Access Compliance Report

Public Rights-of-Way

(Curb Ramps)

Intersection ID: 12267	Main Street: CENTRAL_AV	Cross Street: LOUISE_AV	Location: NW
ADA ID: FE1921A60F49	Ramp Type: Para	Initial Pass/Fail: Pass	Overall Compliance: No
Severity Score: 0			
Codes/Mitigation Info/Possible Solution		Field Measurements/Component Compliance

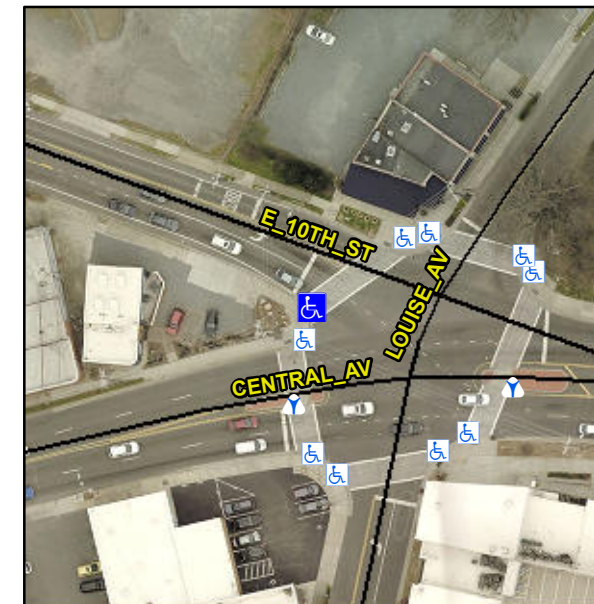
RT RP < 5%

Not Found, R304.2.1, R304.5.3, R305.2

Remove & Replace Entire Ramp.
